Strategic Planning Working Group

Response to Draft Vision 2040.

Mark Booker & Michael Lees, Strategic Planning Group. 9th April, 2024.

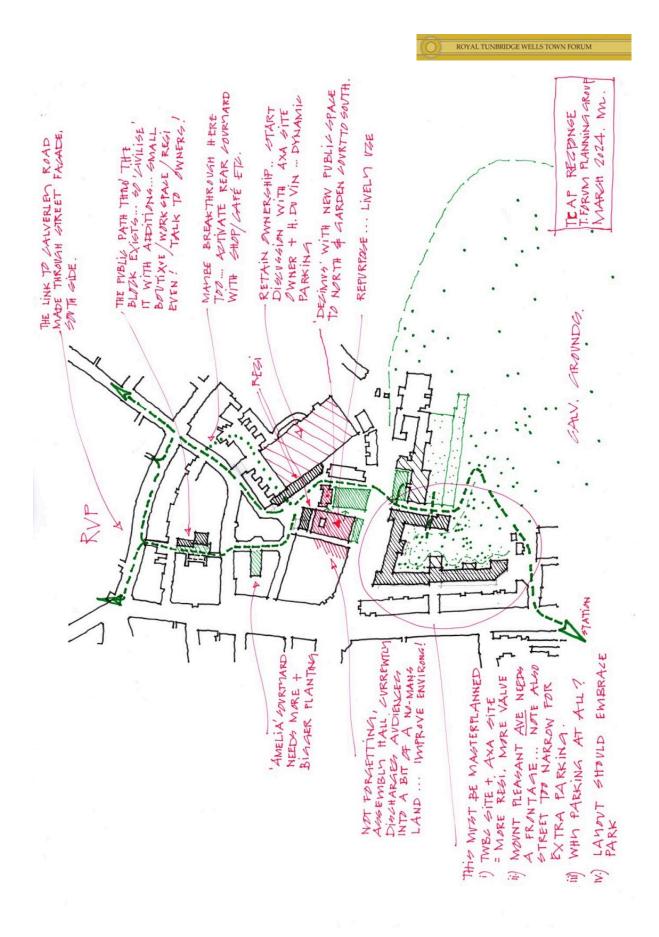
iii.) Recognise that the area currently occupied by Axa Office buildings at Crescent Road should not be processed as a singular project.

This site together with the adjoined TWBC car park site to the south, should only be considered together. As one planned site they form the potential for a needed urban enclosure on the northwest corner of Calverley Grounds , and for an appropriate frontage to the street space of Mount Pleasant Avenue. As one planned site feasible vehicular movement in Mount Pleasant Avenue can be realised. More development, including dwellings, may be realised with a combined site and thereby the asset and social value for TWBC will increase.

A suitable scale for the proposals should be found taking account of the precedent of the scale of the existing AXA blocks.

A resolution for the site should be found through masterplanning and a Supplementary Planning Document, and with the involvement of an interested community representing Calverley Grounds and Hotel du Vin.

A visual illustration of the kind of process which should be applied to this area in drawing up the TCAP is given below. It is given not as any definitive solution but only to show the desired process. It is of the utmost importance that the approach evidenced by this drawing and the analysis on which it is based should be adopted for every physical area to be covered by the TCAP. Only in this way will prospective developers, planning officers and the general public be able to form an appreciation of how it is intended that the town should develop over the plan period. This should inform the Vision 2040 even if individual sites and public realm spaces are not presently capable of being classified as "deliverable" within the meaning of the Local Plan legislative framework.
